Technical Bulletin

Issue#: 103

Subject: SeaEra Base change

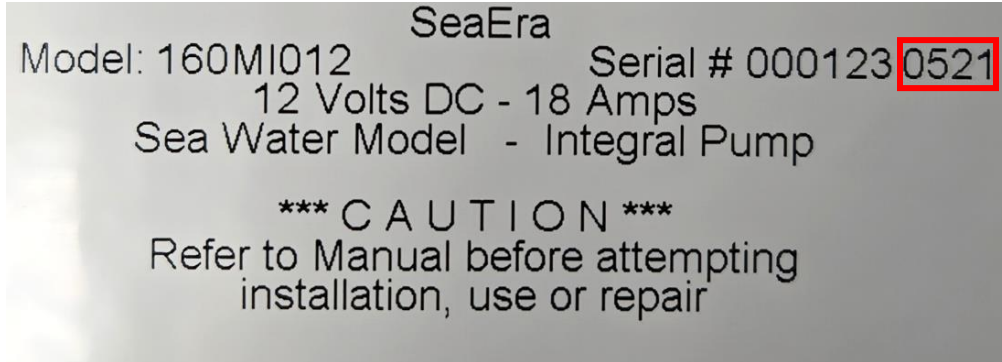
Effective January 1st 2022, a mold change was made to our SeaEra base design. Due to injection mold age and desire to improve the existing design, the base assembly was revamped to include a new base, seal plate and robust o-ring.

All SeaEra models manufactured before January 1st 2022 that require replacement base #161105 or seal plate 161110, must refit those parts with part# 161105AW. This kit includes the 161105A base, 161110A seal plate and 161107A o-ring.

Assembly for remote raw water pump and pressurized fresh water models:

12VDC = 161000AW

24VDC = 161100AW
